PCN-20200115 TE0720-03-2IFC8 eMMC Change

Company	Trenz Electronic GmbH
PCN Number	PCN-20200115
Title	TE0720-03-2IFC8 eMMC Change
Subject	BOM change
Issue Date	2020-01-15

eMMC (U15) is located on top side of PCB:

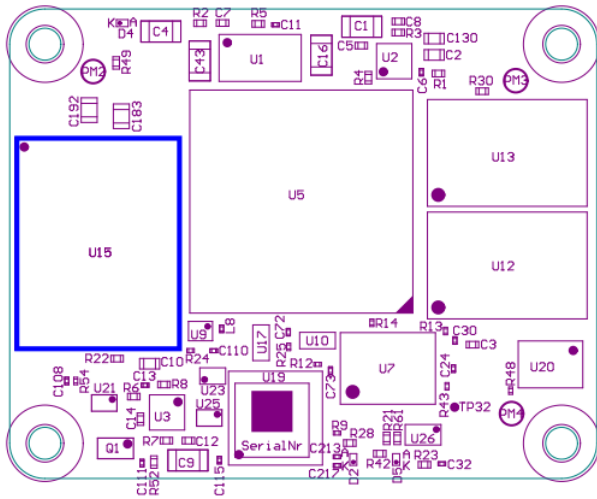
#1 Change eMMC from MTFC32GAKECN-3M to IS21ES32G-JCL

Reason: Old eMMC discontinued.

Impact: The manufacturer ID changed to 9Dh.

new: IS21ES32G-JCLI
